RESEARCH NOTE

How Hydrology Shapes the Design — and Cost — of High-Speed Rail

Date / Consultation Reference
February 2026 | ALTO Consultation open
Jan 15 – Mar 29, 2026

Geological control results in a very pronounced shape anisotropy in the distribution of wetlands with the majority being elongate in te direction of railway alignment

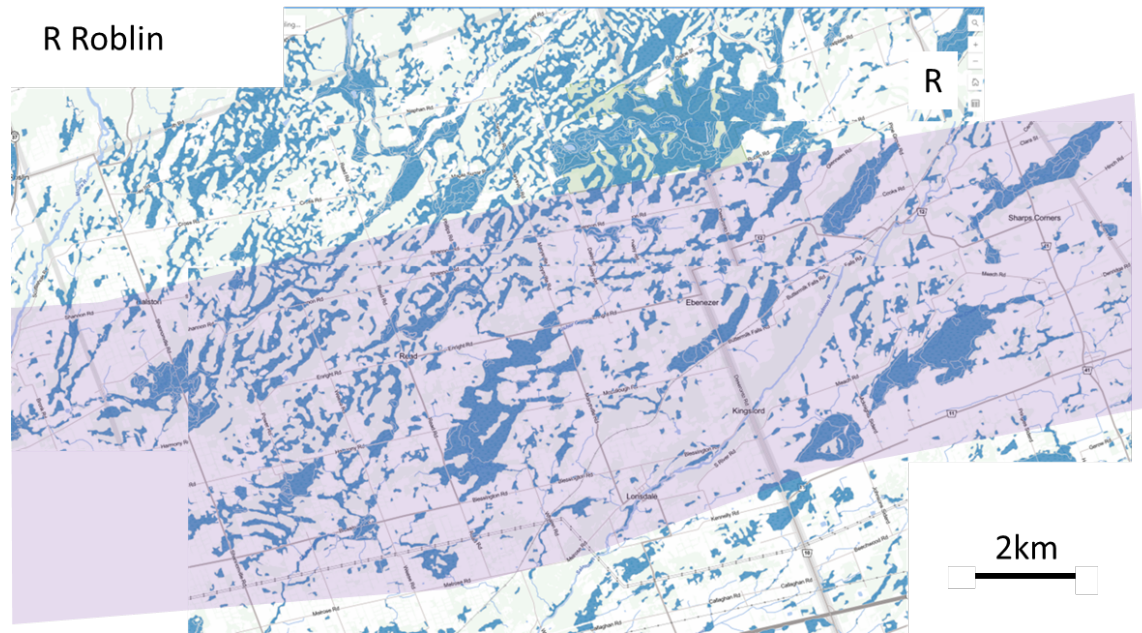
A perception exist that the northern route on shield is poorly drained with many wetland features that need to negotiated. However, just as the geology controls the geomorphology so it controls the distribution and geometry of the wetlands. Within the Mazinaw geological terrane the wetlands, like the lakes, tend to be elongate in the direction of geological strike which fortuitously is parallel with the railway alignment.

The Southern Corridor North of Napanee and south of Roblin.

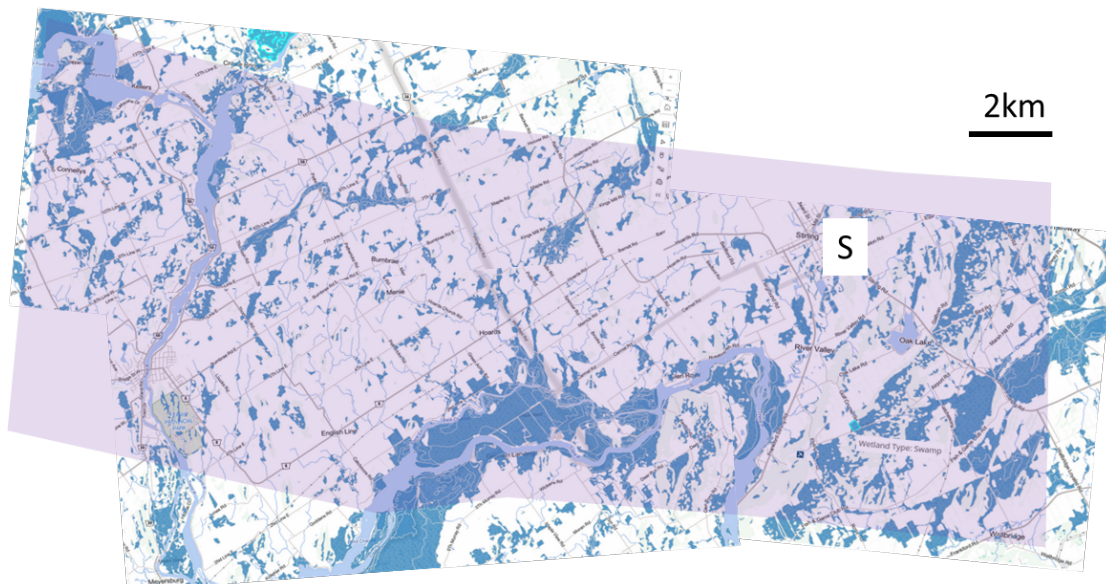
At first glance the southern corridor may seem more attractive since there are less wetlands owing to the agricultural drain that has been conducted over the last 200 years. However, in actual fact the wetland areas are more abundant and considerably more disorganised in distribution and form.

Watercourses for the Northern route. The predominately SW-NE flow patterns are parallel with the railway alignment and result from the interplay of geology, geomorphology and hydrology.

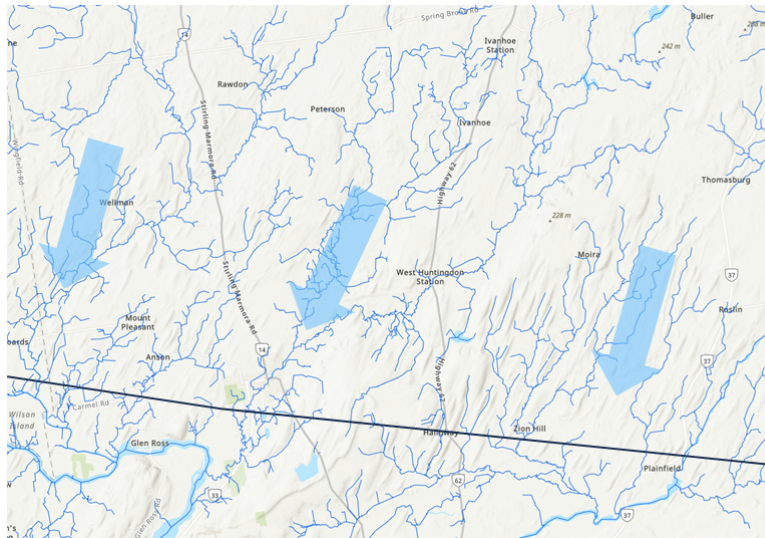
The northern route occupies a “headwater” location near the upper reaches of the Trent river and Rideau River watersheds. Geomorphologically this consists of small elongate wetlands interconnected with streams running NE-SW (Trent catchment) and SW-NE (Rideau catchment).
